# 1992 - 1993 Corvette: Service Bulletin: Cracks/Damage to Cowl Surface

**Subject:** CRACKS OR DAMAGE TO COWL SURFACE

**Model and Year:** 1992-93 CORVETTE WITH RPO LT1 ENGINES ONLY

**Bulletin Number:** 93-134-10

FIGURE 1

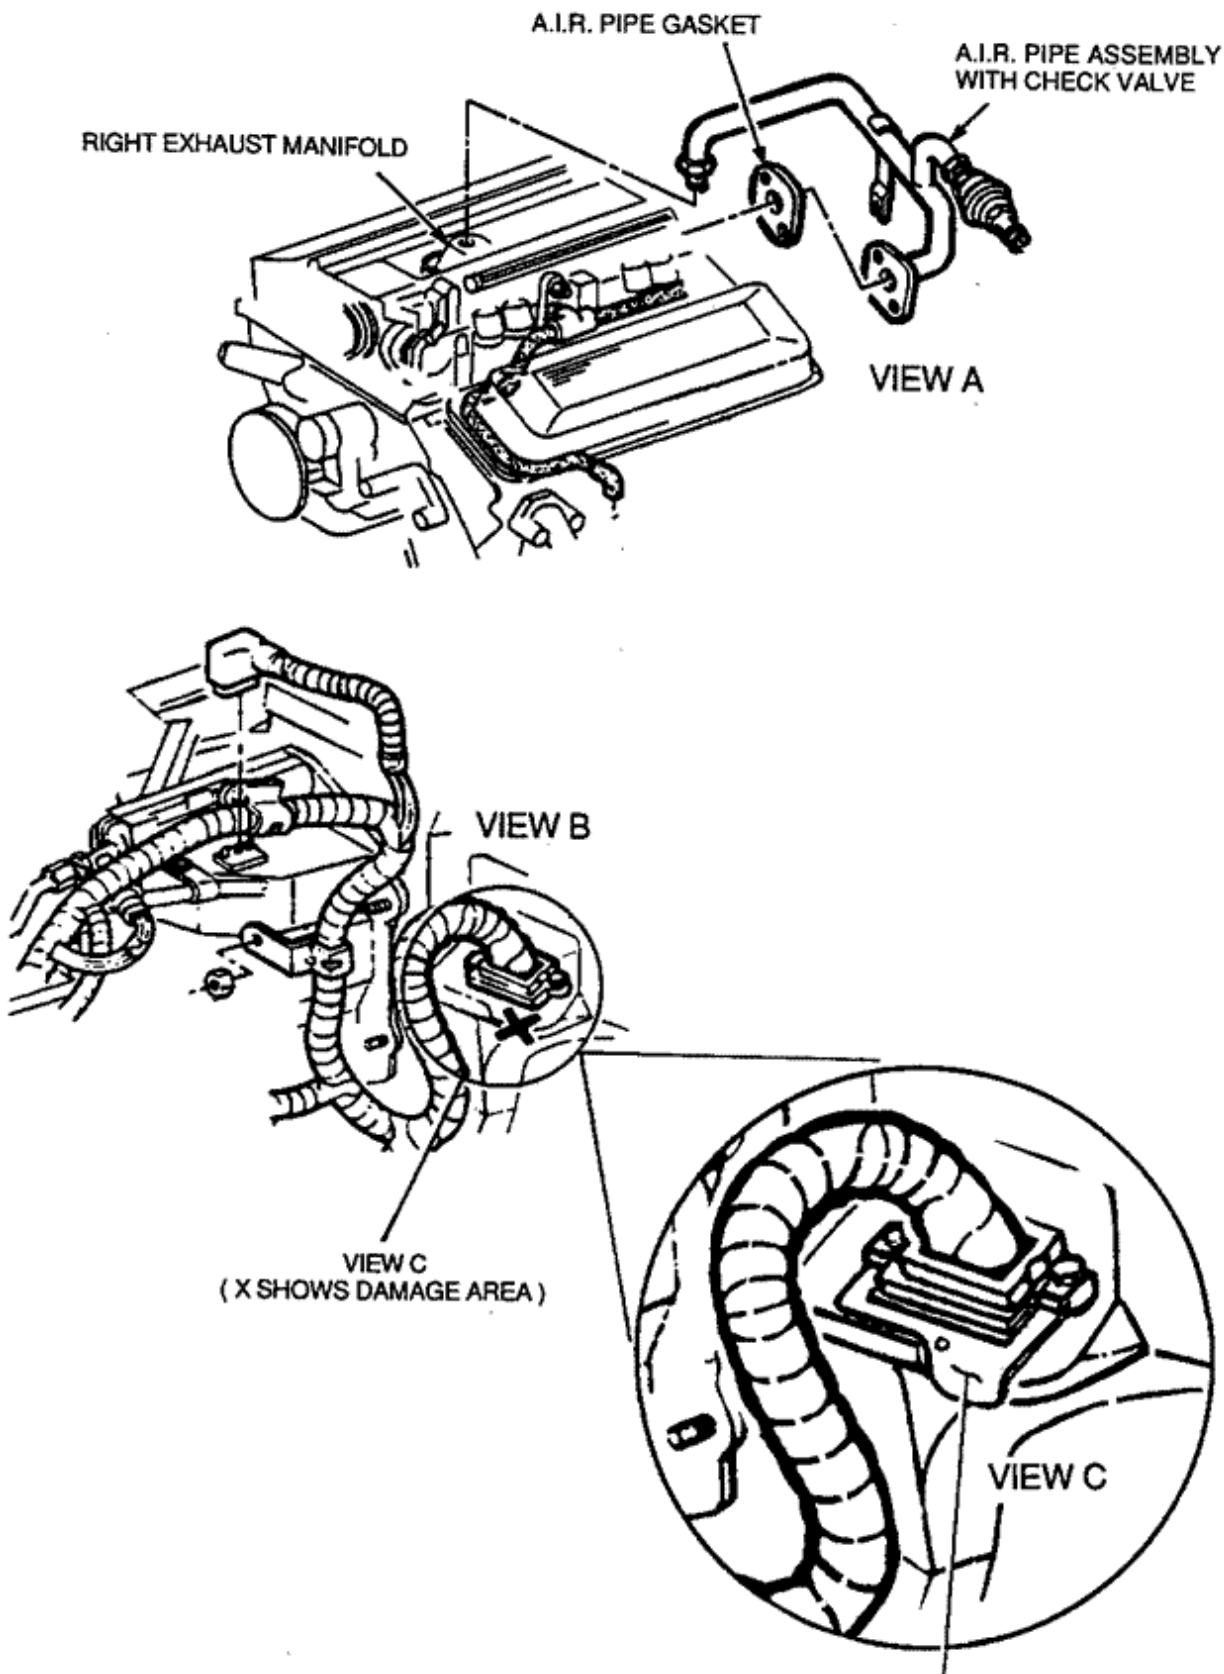
4. Remove right side A.I.R. pipe from engine (See View A);
  - a. Remove nut at exhaust manifold, use 22 mm "crow foot" wrench.
  - b. Loosen bolt on rear of head, using long 9/16" open end wrench.

- c. Remove bolts on rear of intake manifold, use 10 mm 1/4" drive socket and flex extension.
  - d. Remove hose and plastic clamp from check valve.
5. Clean damaged area (See View B) with a wax and grease remover and use V.O.C. approved materials where required.

6. Apply enough seam sealing material to fill or cover the damaged area. Paddle material into place, if required.
7. Loosen the harness connector attaching bolts, position GM P/N 10231336 - Spacer, over the damaged area and under the attaching bolt heads and tighten the attaching bolts. The spacer has slots to aid in installation (See View C).

NEW PART IN POSITION  
OVER DAMAGED AREA
